Application No. 10/660,005
Docket No. P06673US0-HUS5193
Reply to Final Office Action of October 21, 2004

Amendments to the Drawings:

Application No. 10/660,005
Reply to Final Office Action of October 21, 2004
ANNOTATED SHEET SHOWING CHANGES

Fig. 1 amended

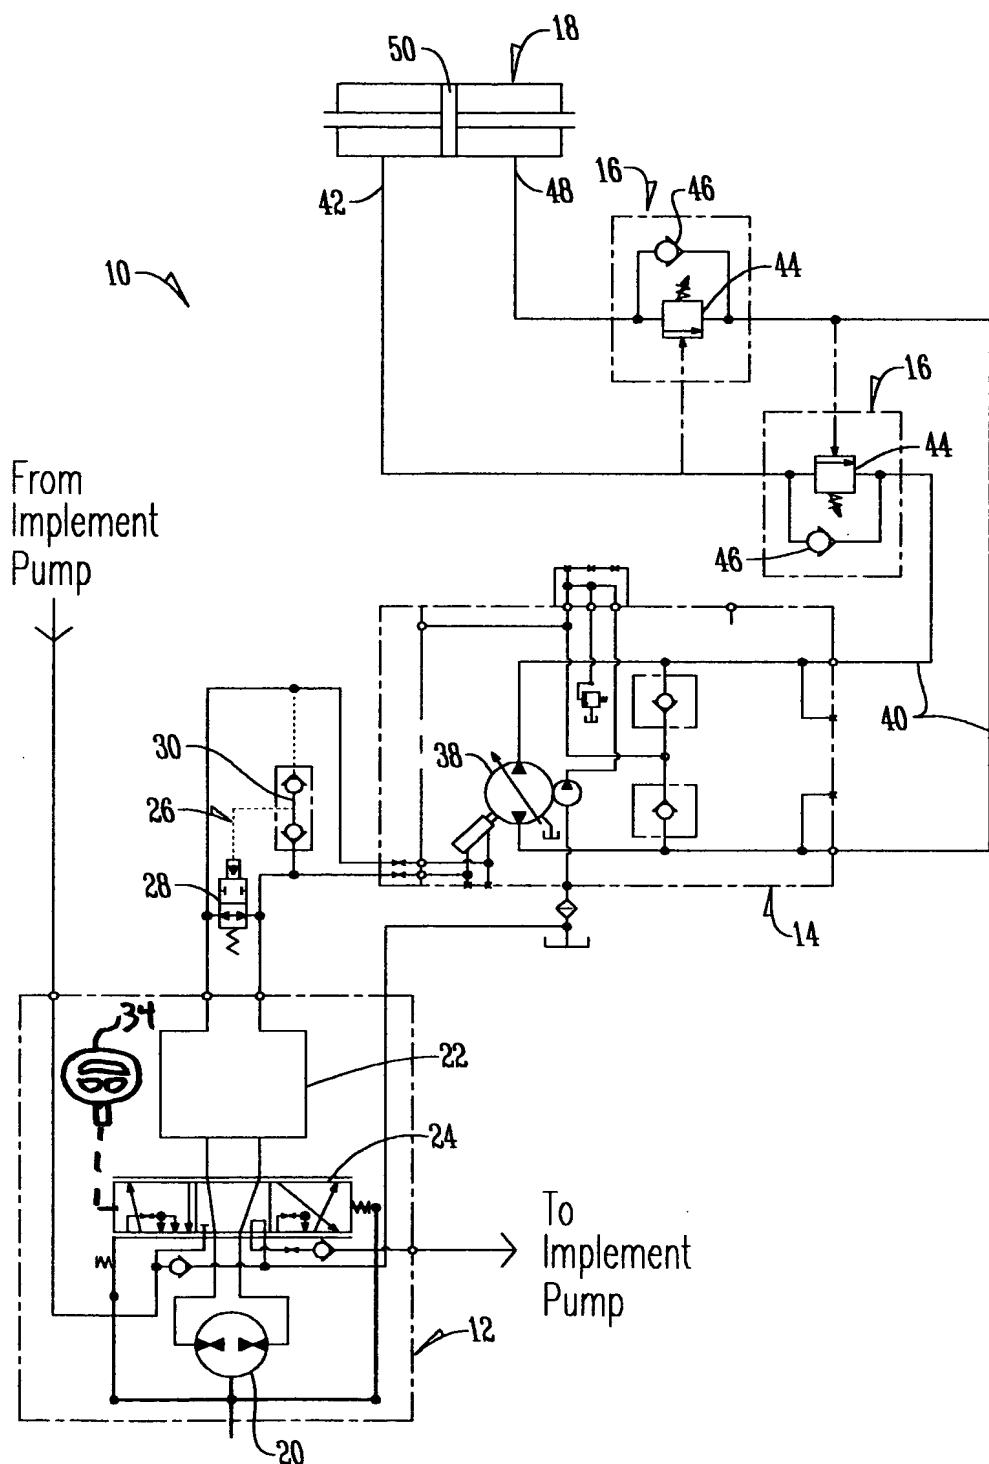
The attached sheet of drawings includes changes to Fig. 1. This sheet, which includes Fig. 1, replaces the original sheet. In Fig. 1, previously omitted element 34 has been added.

The Examiner has maintained his objections to the drawings under 35 C.F.R. 1.83(a) as not showing every feature of the invention specified in the claims. Specifically, the Examiner has maintained his objection that the "steering element" in claim 1 and "steering wheel" of claim 5 are not shown in the drawings.

Previously, the Applicant argued that item 34 shown in Fig. 2 demonstrated the steering element claimed. In response, the Examiner has argued that item 34 shown in Fig. 2 is not the steering element recited in claim 1 which is "a hydraulic steering unit including a steering element for receiving steering input from an operator", where the hydraulic unit is item 12 in the specification and shown only in Fig. 1, and not in Fig. 2.

Accordingly, Applicant has amended Fig. 1 to include steering wheel 34. This Amendment is fully supported by the original disclosure of both claims 1 and 5, as well as the specification at page 5, lines 20-23, reading:

Accordingly, Applicant submits that no new matter has been introduced, and the amended Fig. 1 now provides for the "steering element" and the "steering wheel" claimed in claims 1 and 5, respectively.
